29 November 2023

21-558

167-173 Pilkington Road Clause 23 Further Information

Figure 1 Apirana Road Traffic 2022

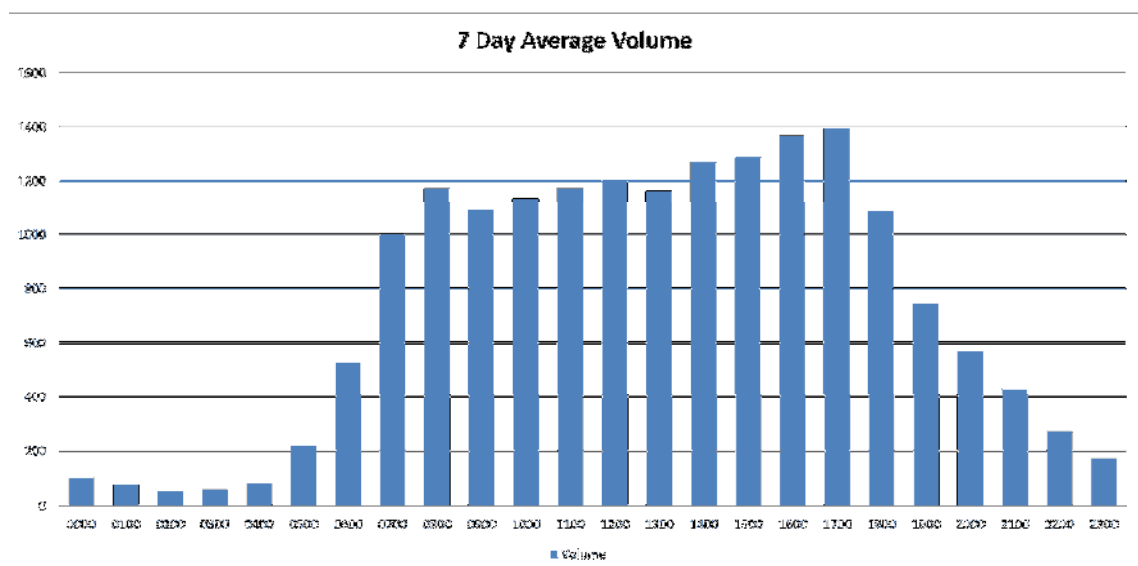
Existing roads Section 3.2 of ITA
Please provide an assessment to determine whether the static traffic volumes on adjoining roads are a result of the local network operating at capacity as opposed to being a result of flattened traffic demand?

I have obtained the traffic count data from Auckland Transport and attached the hourly plot for the 2022 data below.

As can be seen the Apirana Road count has a distinct evening peak hour which indicates there is spare capacity at other times of the day. The lack of any noticeable annual growth shown in the

ITA cannot therefore be the result of the road or adjacent intersections being at capacity throughout the day. This is reinforced by the fact there are queues at times in the two peak periods and not throughout the day.

Figure 2 Cycle Crash 2022 (shown in red)

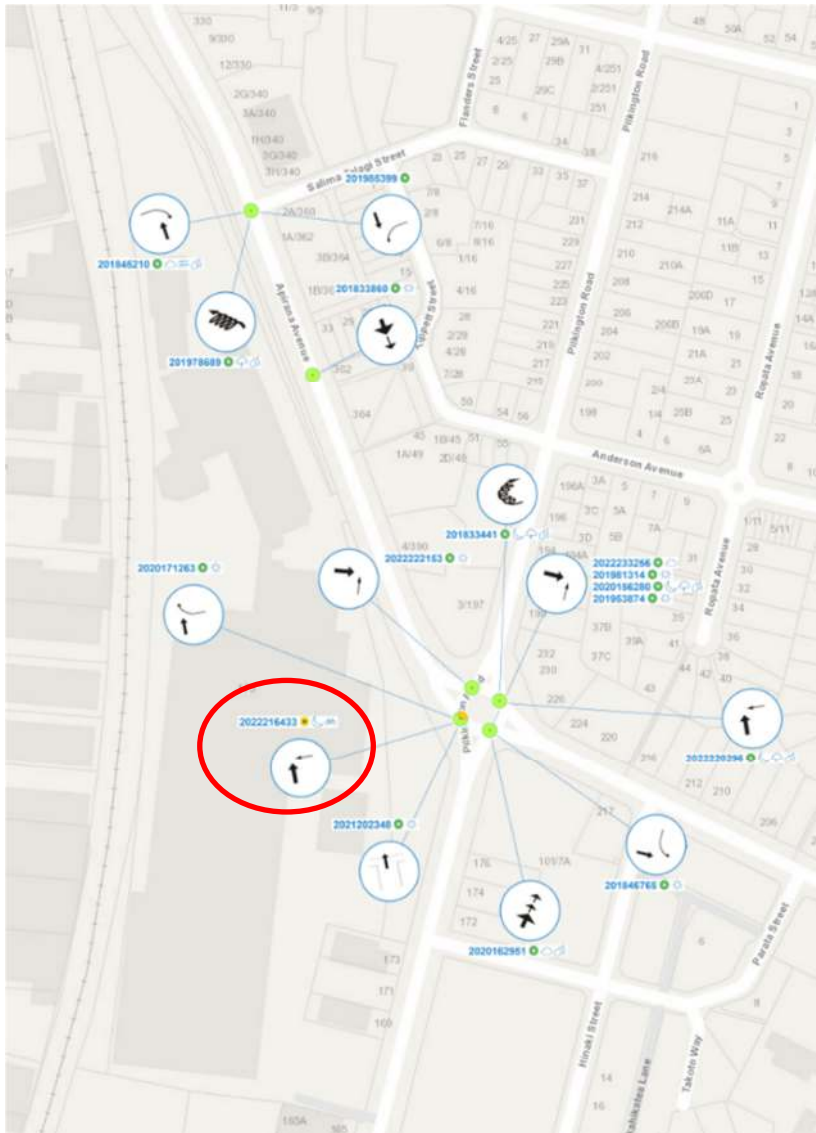
Please advise whether any of the crashes involved pedestrians or cyclists.

None of the reported crashes involved a pedestrian. One reported crash at the Pilkington Road roundabout involved a cyclist as shown in red below.

The crash occurred in February 2022 at 5:45 am during darkness. A car entering the Pilkington Road roundabout from the south failed to give way to a 14 year old cyclist already on the roundabout despite the cyclist having lights and wearing a high visibility top.

Figure 3 Census Journey to Work from Point England and Glen Innes 2018

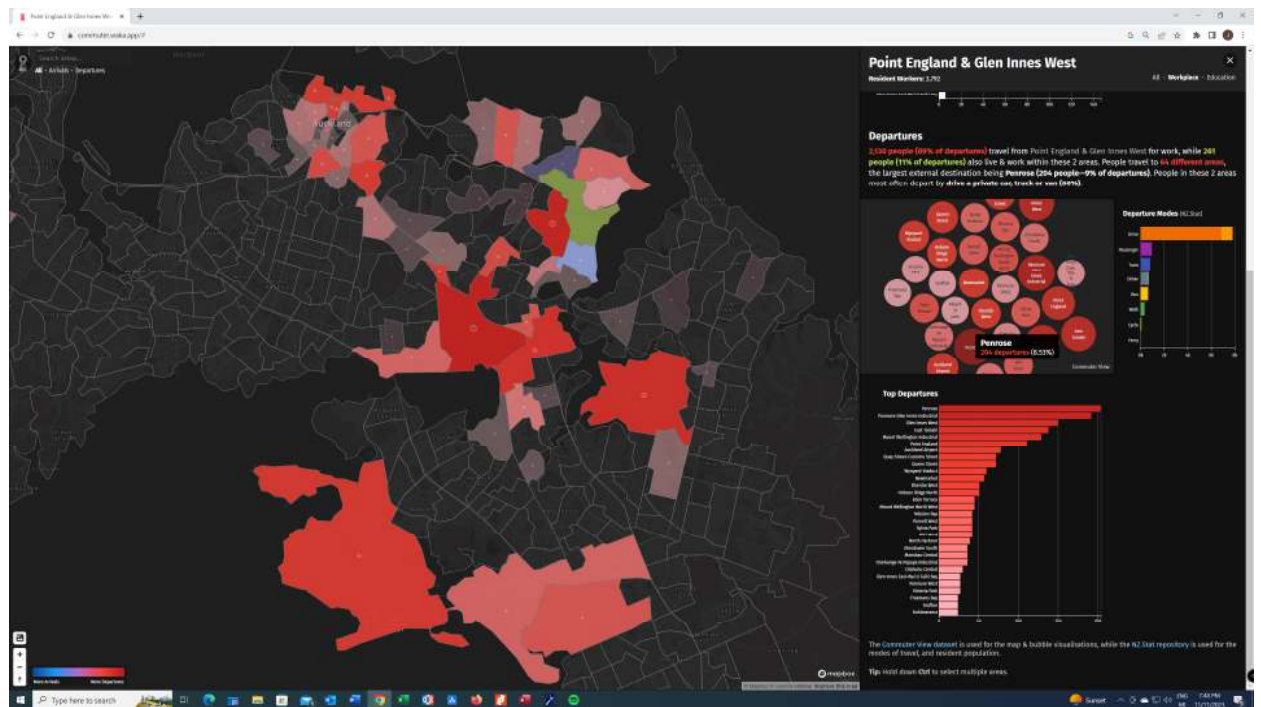
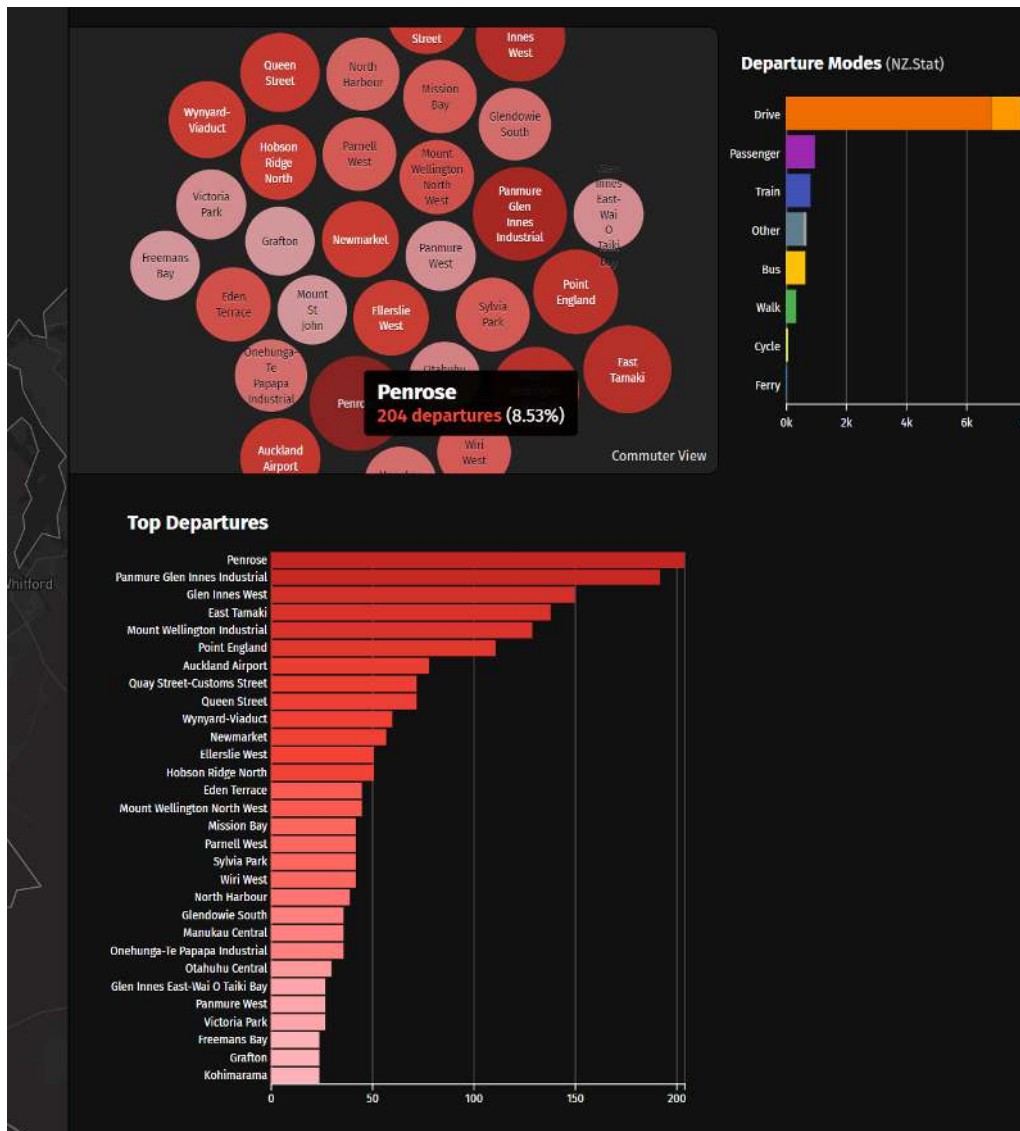
Please outline how figures 29 and 30 relating to future peak hour traffic flows have been developed. Specifically:

What is the basis of the trip distribution assumptions used?

E) The distribution of traffic was developed from the observed counts but modified to reflect the location of likely work destinations. The eight development areas scheduled in the indicative development plan were assumed as internal zones and six external zones were assumed as follows: Merton Rd, Apirana Ave North, Line Road, Pilkington Road North, Tripoli Road, and Pilkington Road south. These external links were then assigned a share of origins and destinations to reflect work and non work trips that might occur based on a broad catchment.

The largest share of morning peak trips were assigned to the south to reflect the strong influence of south Auckland employment zones on travel from the neighbouring two statistical areas of Point England and Glen Innes.

Figure 6 Modified Sidra

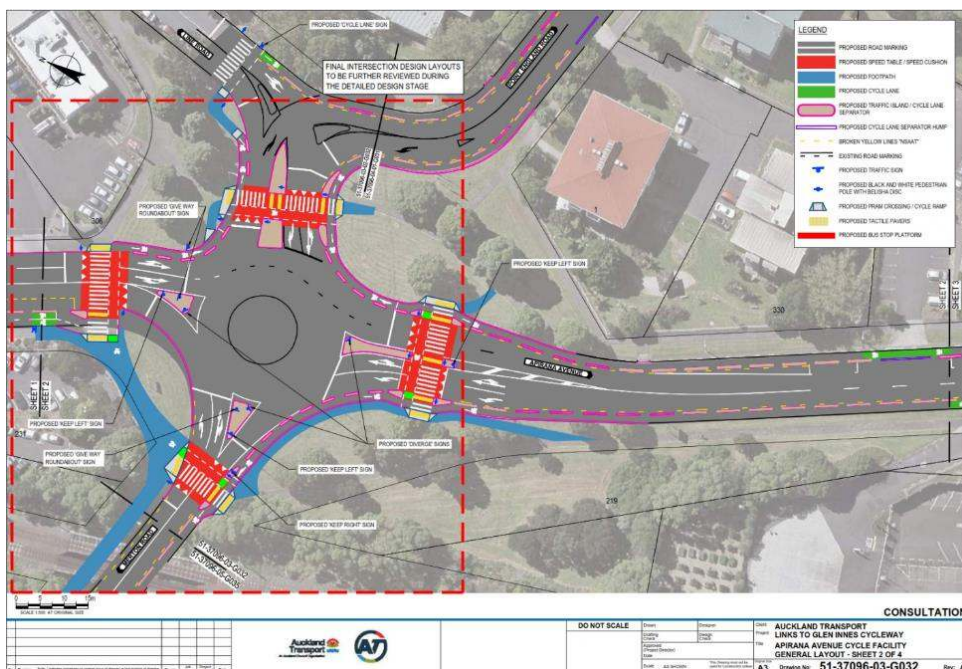
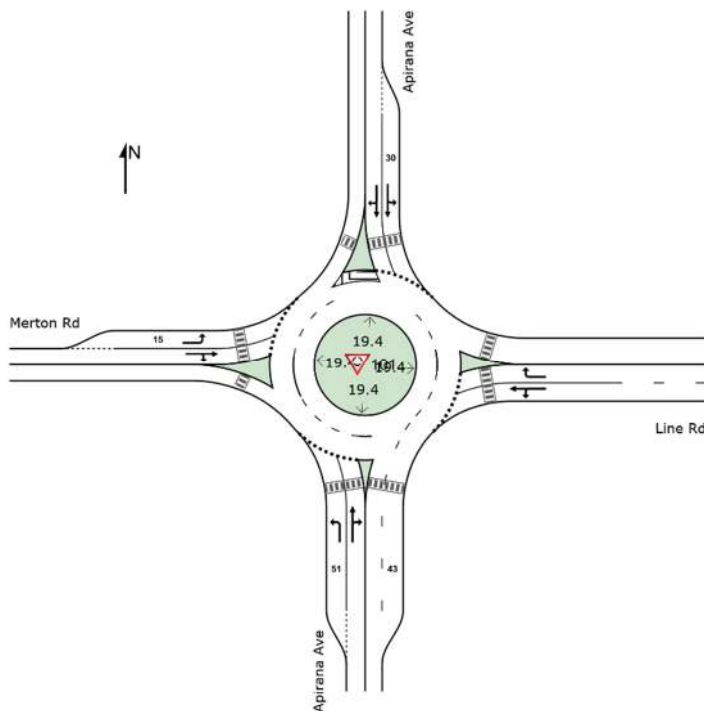
Please undertake a sensitivity test for the Merton Road roundabout to reflect the reduced capacity shown in figure 10 of the ITA?

The reduction in capacity proposed by AT consists of the following changes at the Merton Road roundabout:

- Removal of one departure lane on Merton Road,
- Removal of one departure lane on Apirana Road north of the roundabout;
- Removing through traffic from the right hand approach lane on Line Road;
- Removing through traffic from the left hand approach lane on Apirana Road south of the roundabout.
- The installation of zebra crossings on all four approaches.

To model these changes in SIDRA I have added staged crossings and assumed a flow of 30 pedestrians per hour on each crossing.

As requested I have modelled the impact of these changes by adding them all to the morning and evening base networks. (i.e. without the development). This allows us to see the capacity impact of the proposed works as shown below. I have then added on the development to show the incremental effect of the Plan Change.

We see from the results that the AT project will reduce capacity to a point where oversaturated flow conditions will occur. The issue is that the reduction of departure lanes on Merton Road and Apirana Road north requires the removal of through traffic from one of the approach lanes on Line Road. That will result in a Level of Service F condition on Line Road and a significant queue.

Figure 8 Lower Bound of Footpath Level of Service

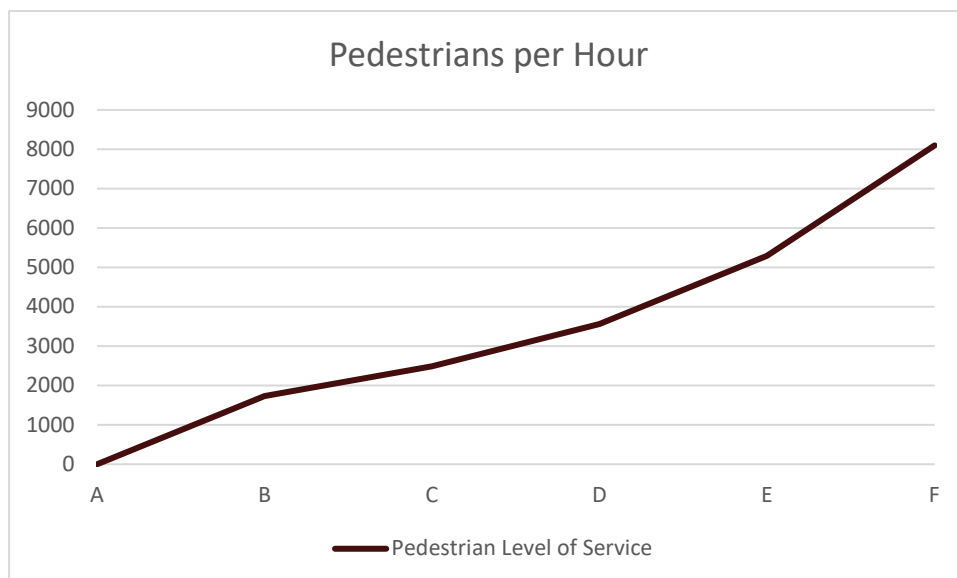
Please provide an assessment of the level of service to be provided for pedestrians. This should focus on the connections across Apirana Avenue to other likely destinations and take into account AT's proposed zebra crossings at the Merton Road/Apirana Avenue roundabout.

LOS Threshold	Flow p/min/m	Total Width (m)	Edge Correction (m)	Useable width (m)	Flow rate ped/min	Capacity ped/hr
A/B	16	1.8	0	1.8	29	1728
B/C	23	1.8	0	1.8	41	2484
C/D	33	1.8	0	1.8	59	3564
D/E	49	1.8	0	1.8	88	5292
E/F	75	1.8	0	1.8	135	8100

This means that provided the footpath carries fewer than 1728 people per hour then it will operate at level of service A and the footpath will not operate at level of service F unless the demand increases to 8100 pedestrians per hour. Based on the development enabled by the plan change, it is expected that a level of service A will be maintained. We can conclude the footpath capacity is not an issue for the plan change.
